### 3.1.2 Pressurization, Heatup, and Cooldown Limitations

SAFETY EVALUATION BY THE OFFICE OF NUCLEAR REACTOR REGULATION

SUPPORTING AMENDMENT NO. 56 TO LICENSE NO. DPR-38

OCONEE NUCLEAR STATION, UNITS NOS. 1, 2 AND 3

Figure 3.1.2-1C

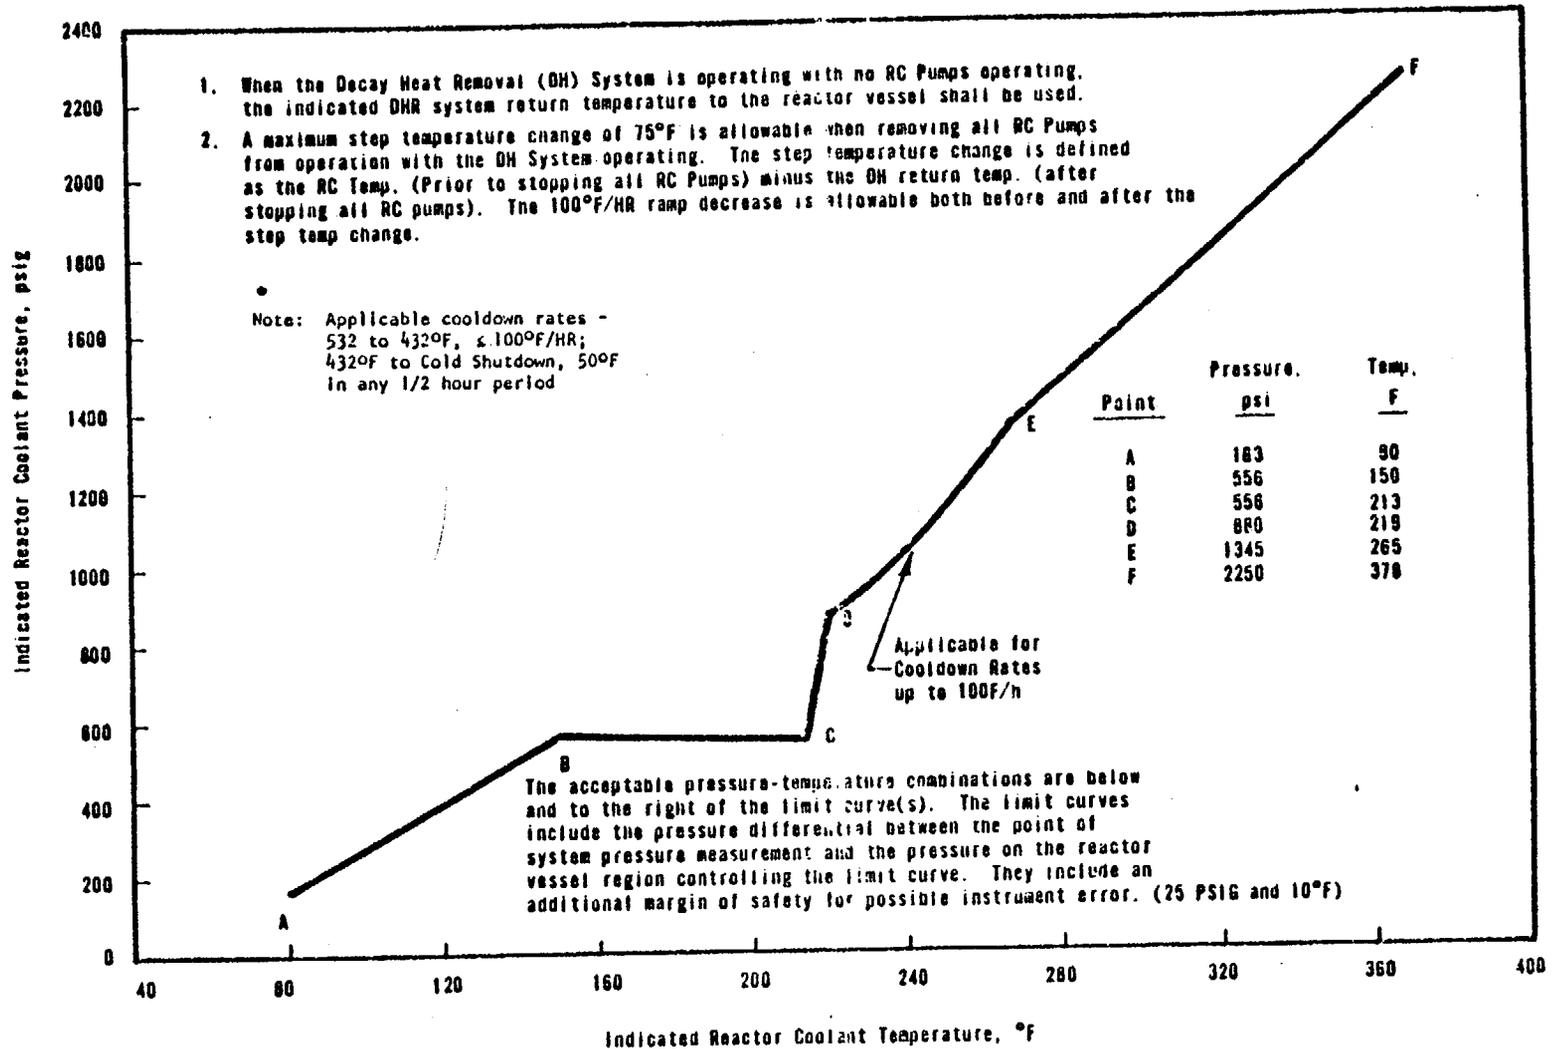
UNIT 3  
 REACTOR COOLANT SYSTEM  
 NORMAL OPERATION HEATUP LIMITATIONS  
 APPLICABLE FOR FIRST 4.0 EFY

The proposed revised Oconee Unit No. 3 pressure-temperature operating limit curves, Figures 3.1.2-1C, 3.1.2-2C and 3.1.2-3C are based on data from Babcock & Wilcox Report, "Analysis of Capsule OCIII-A From Duke Power Company Oconee Nuclear Station, Unit No. 3, Reactor Vessel Materials Surveillance Program," BAW-1438, dated July 1977. The proposed curves are projected for 8 EFPY.

We have reviewed BAW-1438 and the proposed pressure-temperature operating limit curves. Capsule A from Unit No. 3 contained specimens of weld metal WF 209-1. This weld is not identical to the welds in Oconee Unit No. 3. However, this weld has a similar chemical composition and was made using weld procedure similar to those for high copper Oconee vessel welds. Therefore, we conclude that the properties of the limiting weld metals in the Oconee reactor vessels will be affected by irradiation in a manner similar

to these WF 209-1 specimens. Also, the Oconee Unit No. 3, Unit No. 2, and Unit No. 1 neutron flux, flux spectrum and weld material mechanical properties are similar. The Oconee Unit No. 1 pressure-temperature limits were approved on February 23, 1977, and were applicable for 4 EFPY. The Oconee Unit No. 2 pressure-temperature limits were approved on November 4, 1977, and were also applicable for 4 EFPY. For the reasons stated in our Safety Evaluation Report issued February 23, 1977 on Oconee Unit No. 1, and on November 4, 1977 for Oconee Unit No. 2 we have concluded that the proposed temperature operating limit curves for Unit No. 3 should also be limited to 4 EFPYs of operation.

Based on our review of the Oconee Unit No. 3 pressure-temperature limits and the similarity of the Oconee Unit No. 3, Unit No. 2, and Unit No. 1 designs, materials and operating conditions, we conclude that the operating limits proposed for Unit No. 3 are in conformance with Appendix G, 10 CFR Part 50, and are therefore acceptable.

Figure 3.1.2-2C

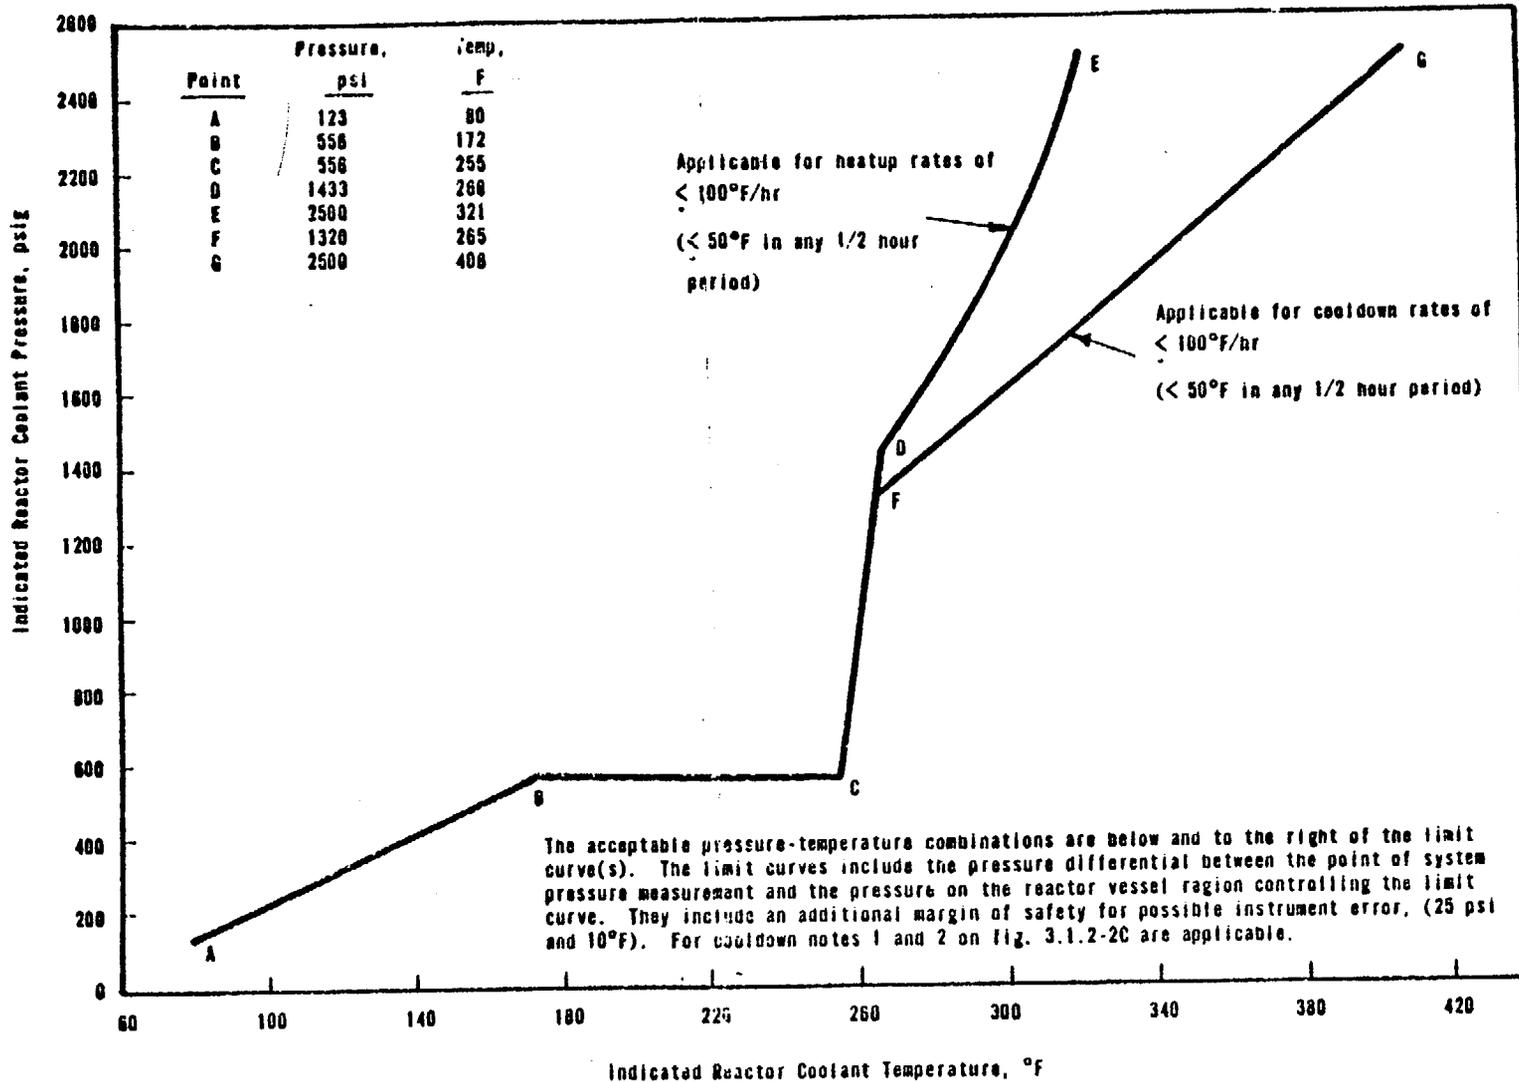
UNIT 3  
 REACTOR COOLANT SYSTEM  
 NORMAL OPERATION COOLDOWN LIMITATIONS  
 APPLICABLE FOR FIRST 4.0 EFPY
